SAFETY EVALUATION BY THE OFFICE OF NUCLEAR REACTOR REGULATION  
EVALUATION OF RCS THERMAL SLEEVE PROBLEMS IN WESTINGHOUSE PLANTS

ROCHESTER GAS AND ELECTRIC CORPORATION

R. E. GINNA NUCLEAR POWER PLANT

DOCKET NO. 50-244

FIGURE 4

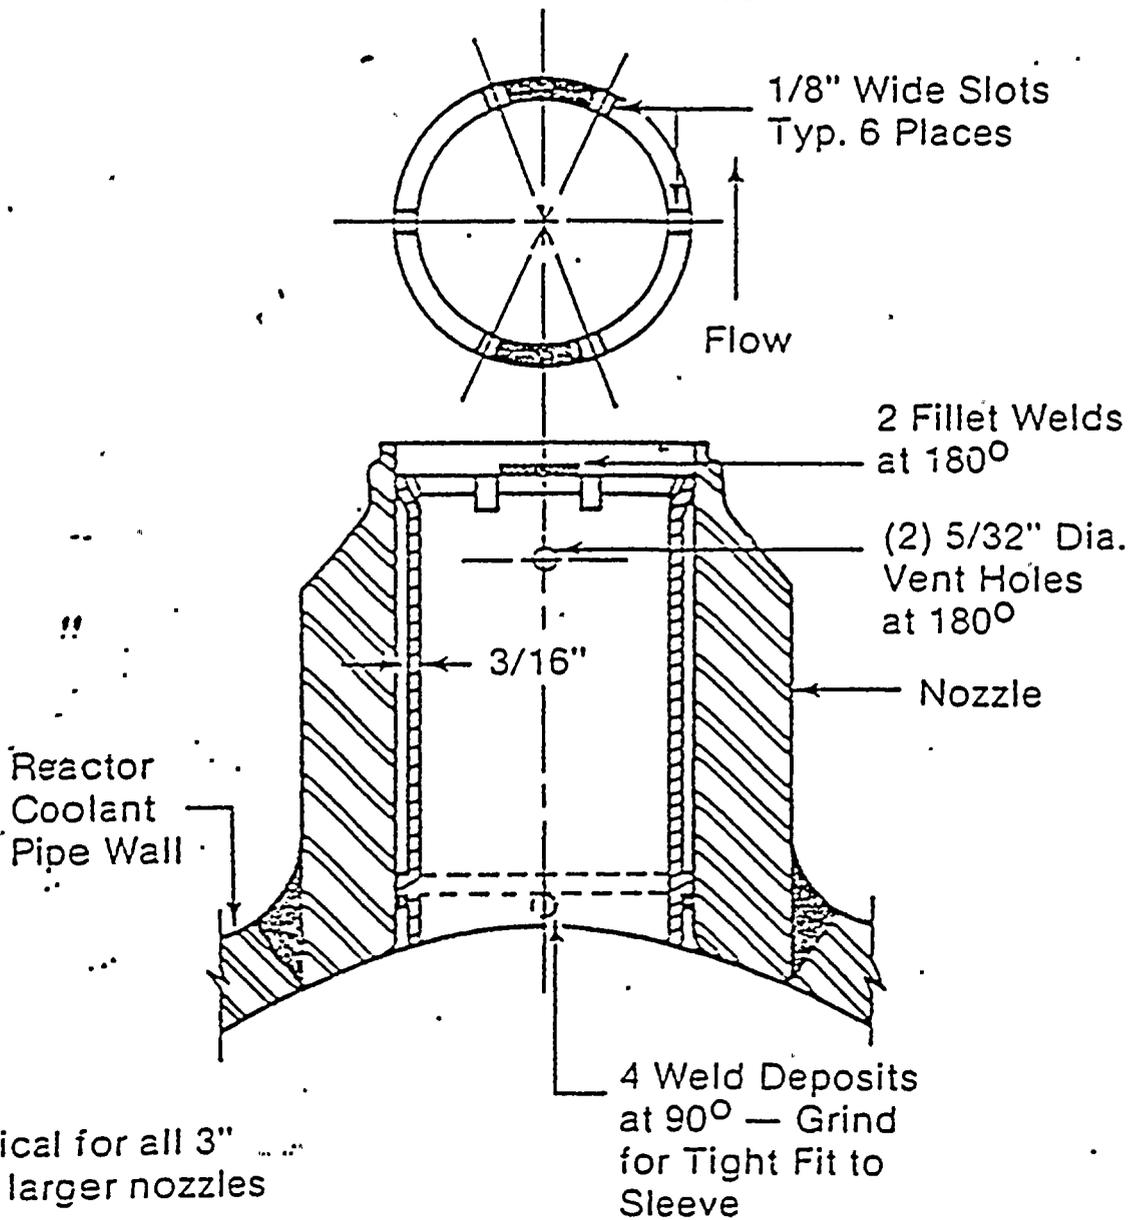
Westinghouse investigation concluded that these occurrences have been confined to those thermal sleeves of "Generation 3" design (Figure 4), which utilize

2 fillet welds 180° apart at the upstream attachment, instead of a continuous 360° weld used in other design. The failures were attributed to attachment weld cracking, which was caused by high cycle fatigue due to flow induced vibrations. The failure mechanism was substantiated by metallurgical evidence found at the failed welds. Initiation of cracks occurred on the ID and failure occurred through transgranular cracks propagated by the failure mechanism. Westinghouse has also indicated that sleeves of earlier design (i.e. Generation 0, 1, 2) remain intact due to the fact that earlier design codes required the use of larger design margins.

1. By comparing the configuration of the various generations thermal sleeves (Figure 1 to 4), the "Generation 3" sleeve is the only design utilizing two brief welds 180° apart at the upstream attachment, instead of a continuous 360° weld as used in other designs. Consequently Generation 3 design sleeves are (a) subjected to more severe excitation due to bypass flow through the unwelded gap, and (b) the sleeves are more flexible and responsive to flow excitation due to less rigid constraint at the weld attachment. Thus high cycle stresses due to flow-induced vibration cause fatigue failure at the attachment welds. We concur with the Westinghouse finding on failure mechanism as described in Paragraph III above, and our evaluation also conclude that the 360° weld for "Generation 4" sleeves is justifiable and acceptable.

C. For operating plants using thermal sleeves of "Generation 3" design:

- 1: Removal of thermal sleeves at reactor coolant loop branch line nozzles is acceptable provided a program is implemented per revision of the Technical Specifications to monitor the occurrence of injection flow transients and evaluate their fatigue usage factors for nozzles specified in item B above. Action is not required until the

2. For those nozzles having intact thermal sleeves, in lieu of sleeve removal the option to retain sleeves in place during continued plant operation is acceptable, provided a program to inspect attachment welds of these sleeves at each refueling outage is initiated. The program should be submitted for NRC approval.

Sleeves should be removed or replaced should any degradation of the attachment welds be found. Action requirements after removal of sleeves are as specified in items C.1 above.
